Subject: WATER AND WASTEWATER CAPACITY AVAILABILITY LETTER 527 Orton Avenue, DRC#R18004 527 Orton Avenue, Fort Lauderdale, Florida 33304

City of Fort Lauderdale Public Works Department Water and Wastewater Capacity Analysis

527 Orton Avenue, DRC#R18004 527 Orton Avenue, Fort Lauderdale, Florida 33304

CAM # 18-1324 Exhibit 5 Page 3 of 7 Figure 1 – City Water Atlas

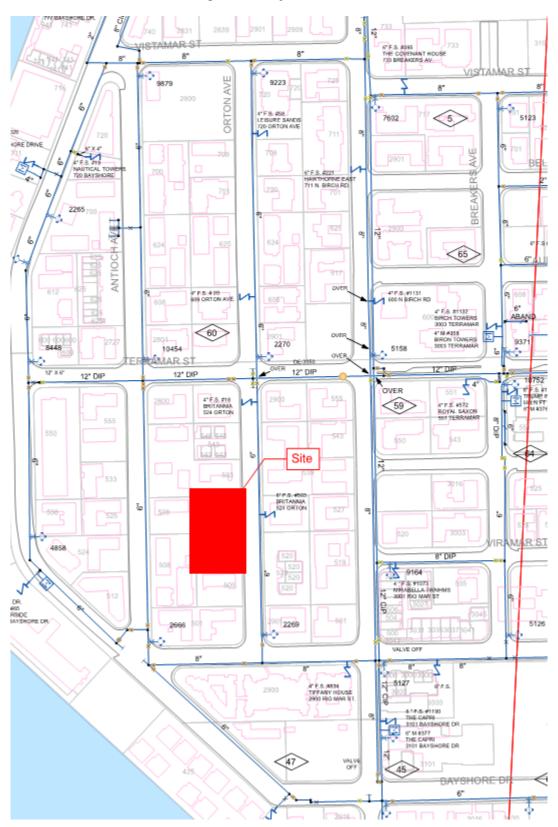
Water: The site is currently served by a 6-inch water main along Orton Avenue which connects to 8-inch water mains along Vistamar Street and Riomar Street. See Figure 1.

Evaluation of impact on existing distribution pipe (flow & capacity): According to the site plan the applicant is proposing to utilize the 6-inch water main on Orton Avenue. The InfoWater hydraulic model was analyzed to determine the impact of this project on the existing 6-inch water. The existing water main has capacity to serve the project.

Figure 2 – City Sewer Atlas

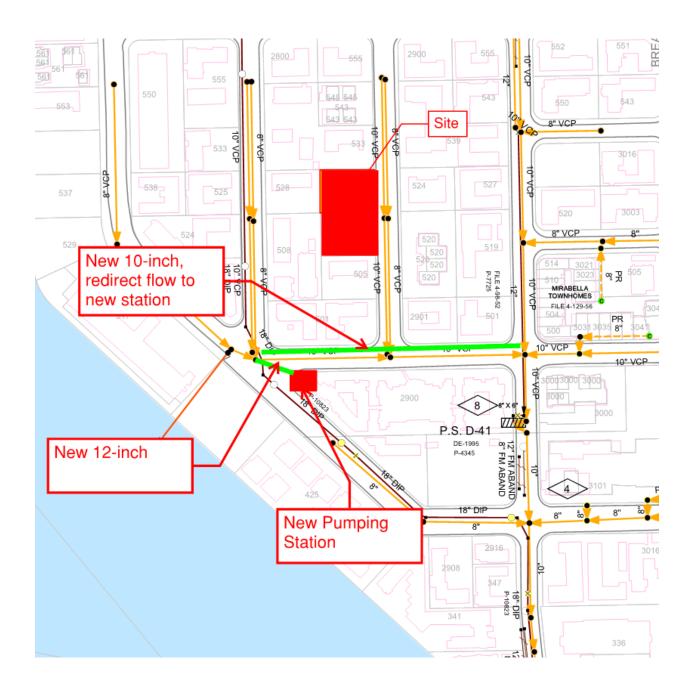
Wastewater: The site is currently served by a 10-inch gravity sewer main which conveys flow downstream to a 10-inch sewer on Riomar and to pumping station D-41. See Figure 2. A new 10-inch and 12-inch gravity sewers are to be installed to route flow to the new pumping station D-41 under City Project 12124.

Evaluation of impact on existing collection pipe (gravity system capacity): The existing site and adjacent buildings are served by 10-inch gravity sewer mains.

Manual of Practice (MOP) 60, published by American Society of Civil Engineers (ASCE) for the gravity sewer design and used by the City staff, recommends that pipe diameters 15-inch or less be designed to flow half full during peak flows. Based on the tools and information available to the City staff, it has been calculated that the 10-inch diameter pipe will flow 4% full from the projected flow, which less than ASCE is recommended 50%. The City has used a peak hourly flow factor of 3.0, which is higher than 2.2 as noted in the Reiss Report. Therefore, the 10-inch pipe is adequate to serve the project.
